**PLANNING PERMIT APPLICATION P/2021/6169 Subdivision
609 to 621 Burwood Highway, Knoxfield
Response to Request for Information**

We write on behalf of Development Victoria (the applicant) in relation to planning permit application P/2021/6169 (subdivision) at 609 to 621 Burwood Highway, Knoxfield. The purpose of this correspondence is to provide a response to the further information request issued by Knox City Council (Council) in relation to the abovementioned planning permit application. We note that the responses have been prepared by Development Victoria and its full project team.

Drawing Title KNOXFIELD RESIDENTIAL DEVELOPMENT SITE VEHICLE ACCESS SWEPT PATH ANALYSIS	
Designed MOB		Meiway Ref 73 D1	
Scale 1:200 @ A3		Project Number 190752	Drawing Number SPA401
		Revision A

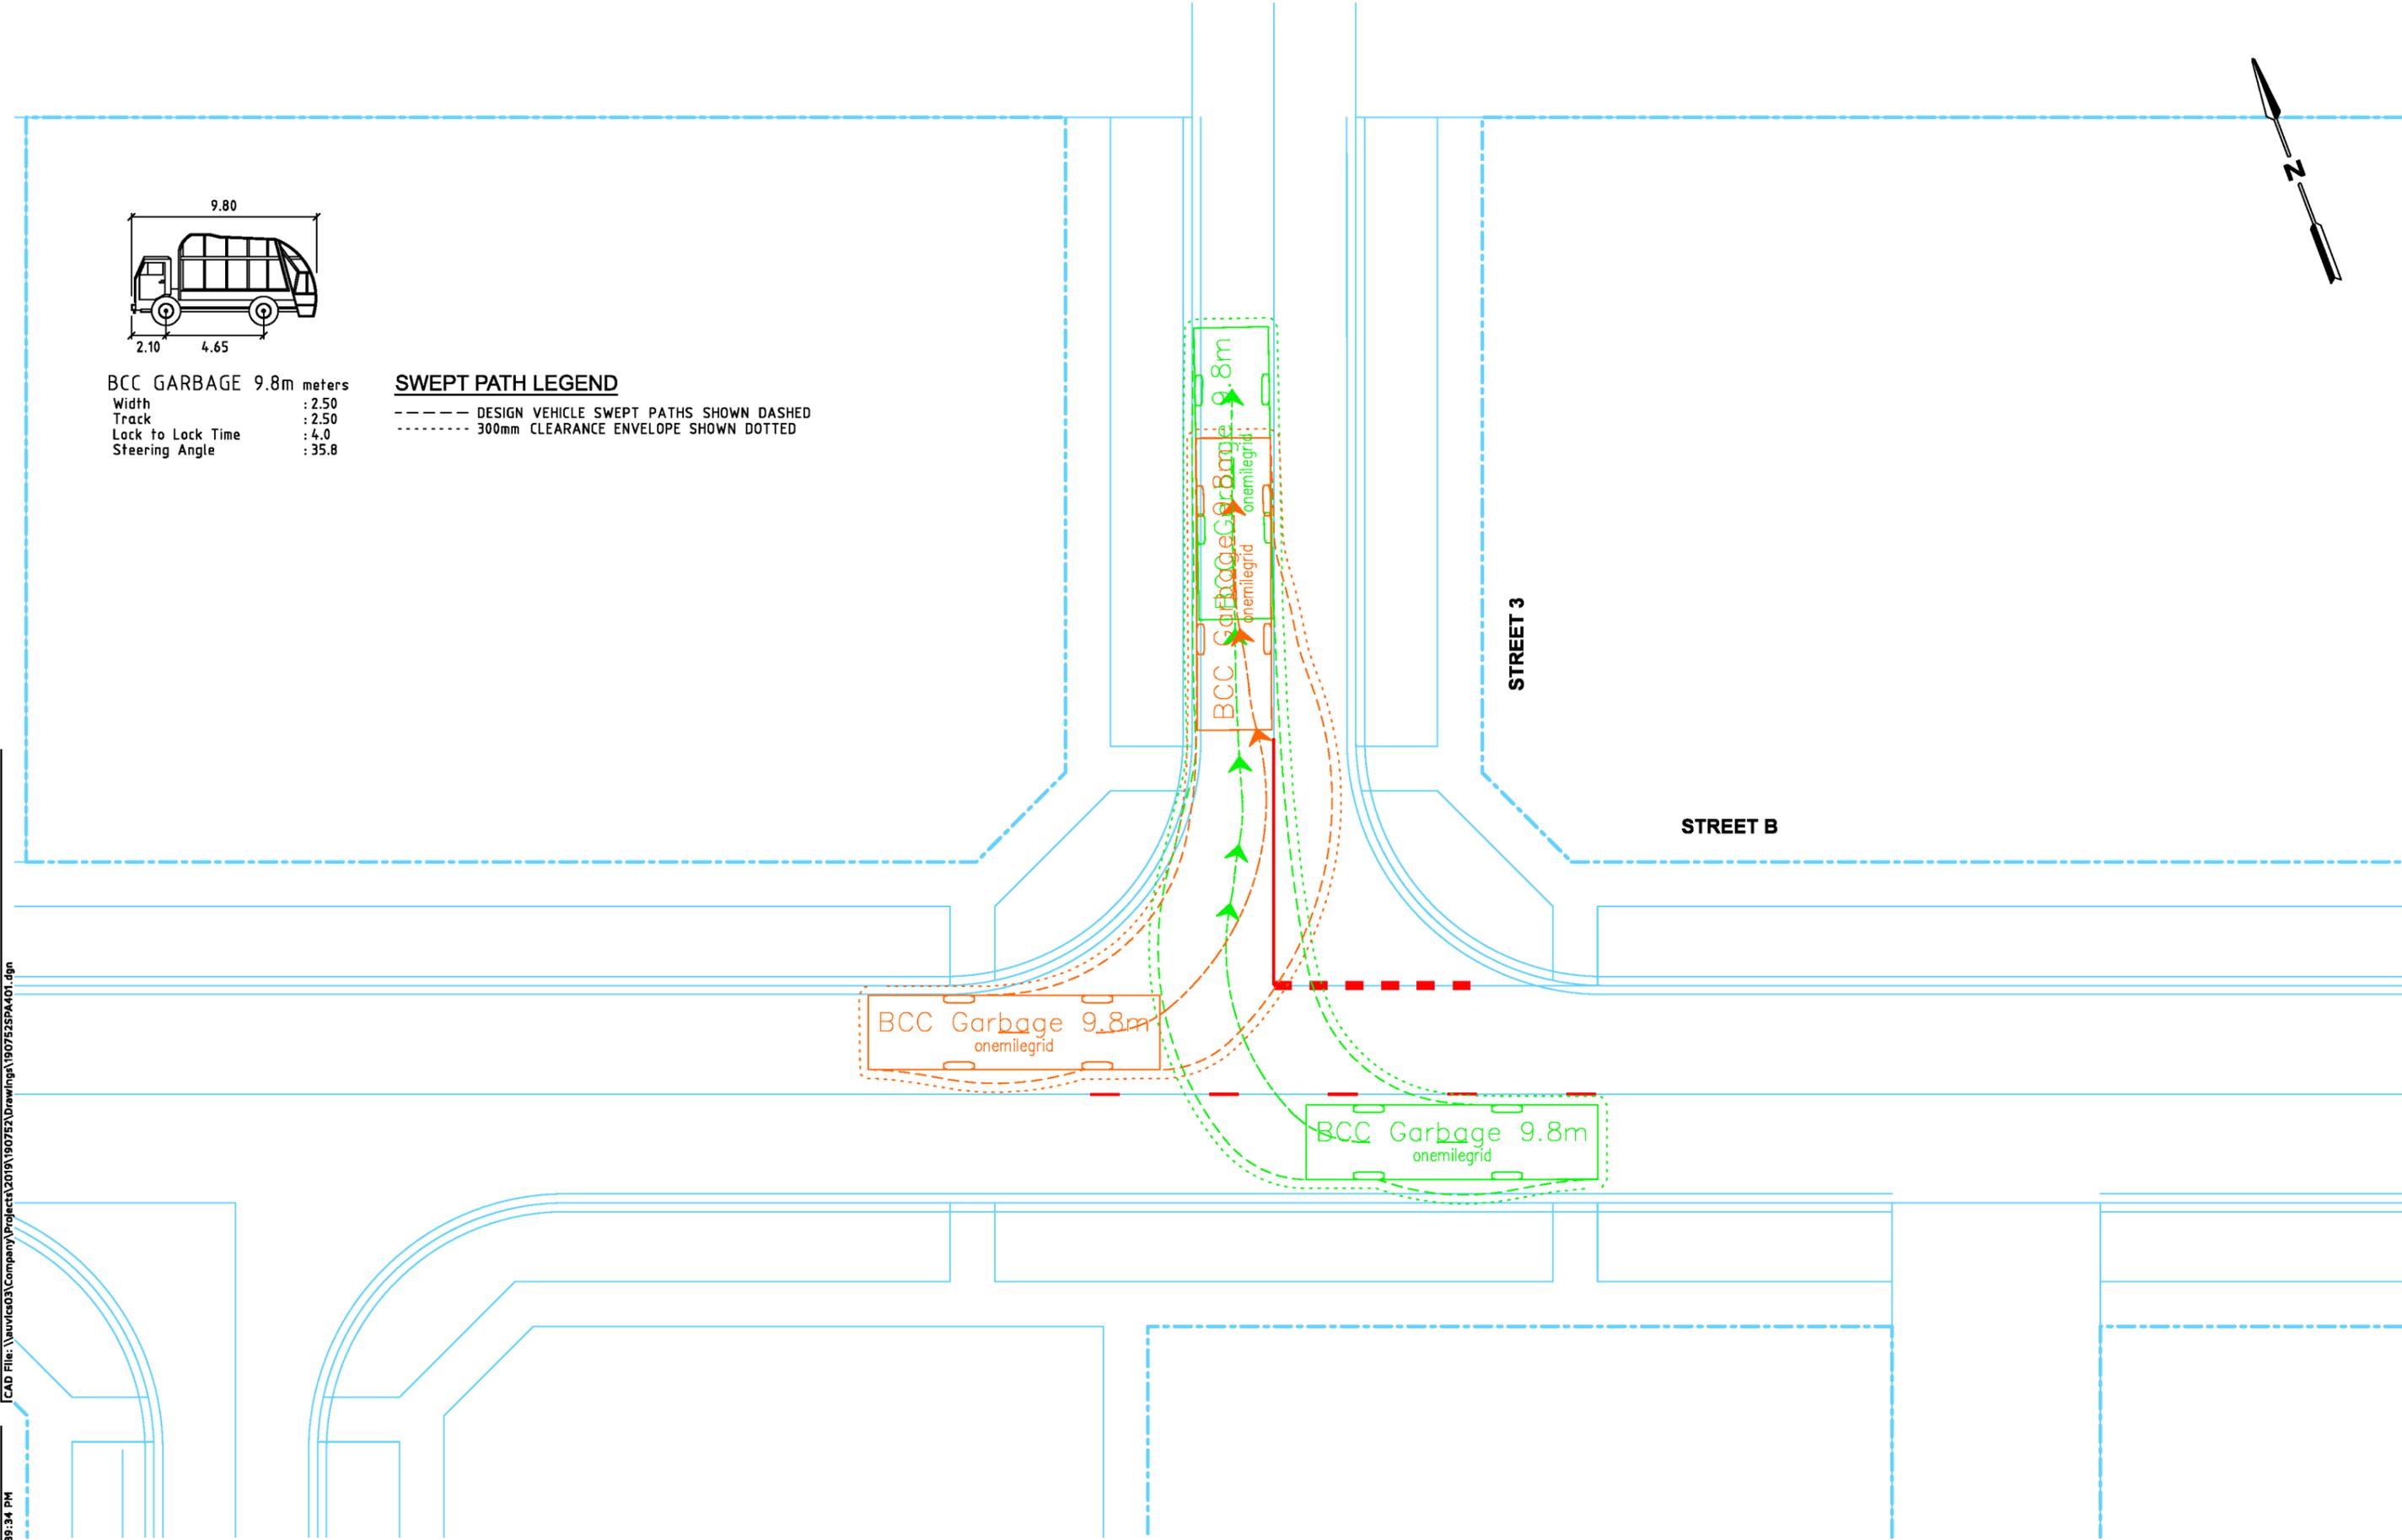
Swept paths for collection vehicles to be provided on Plan Drawings to demonstrate accessibility for collection vehicles including on-site manoeuvring, and confirmation entry and exit into and from the development can be in a forwards direction. If visitor car parking spaces are to be utilised for collection vehicle turning area(s), confirmation of how car parking spaces will be kept clear on collection days is required.

Similarly, the internal intersections are designed as standard residential T-intersections, with standard kerb radii, which are designed to allow for the required vehicles. Swept paths (refer appendix C typical swept paths) for a standard intersection design, show the movement of cars and service vehicles. It is acknowledged that should a passenger vehicle and a service vehicle arrive at the intersection simultaneously, the service vehicle may need to allow the passenger vehicle to leave the intersection before continuing, as is standard practice at the majority of residential intersections in the Municipality.

Drawing Title KNOXFIELD RESIDENTIAL DEVELOPMENT SITE VEHICLE ACCESS SWEPT PATH ANALYSIS	
Designed MOB		Meiway Ref 73 D1	
Scale 1:200 @ A3		Project Number 190752	Drawing Number SPA402
		Revision A

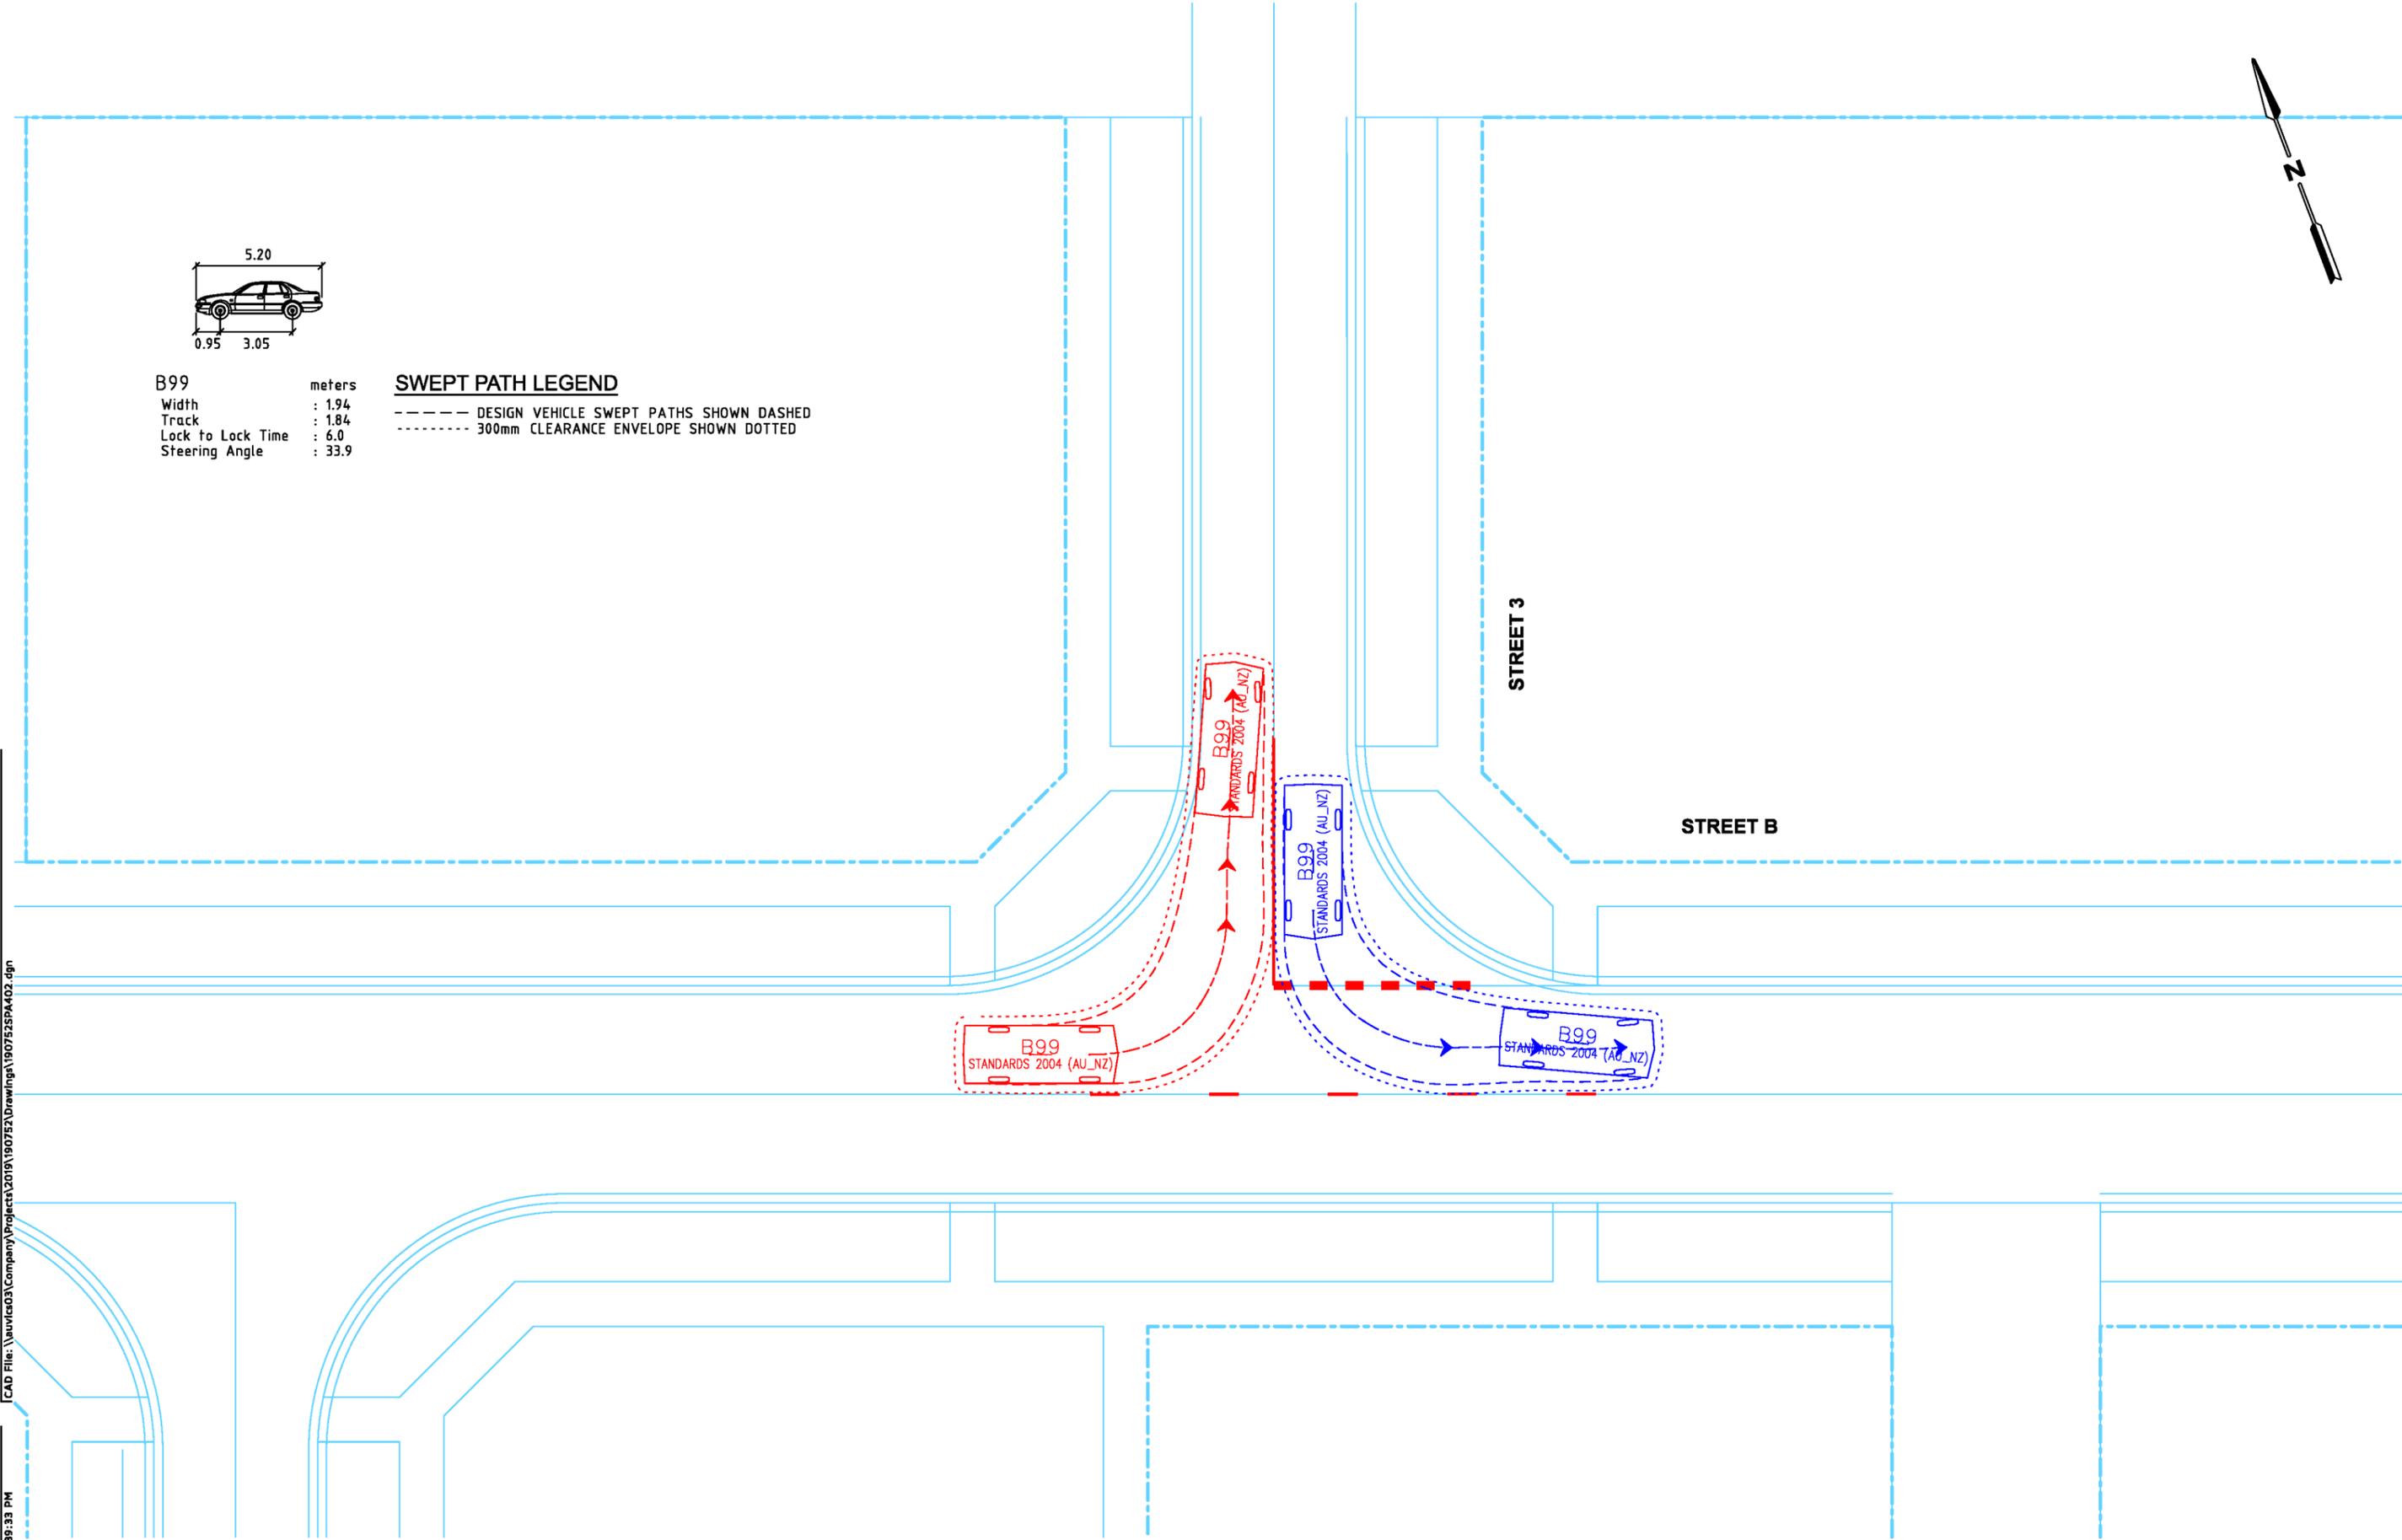
The landscape master plan provides some details on the lot layout, footpath, and indented parking bays. However, details relating to the location of crossovers and garages are needed to check for turning access movements. This is especially important for a narrow rear laneway access.
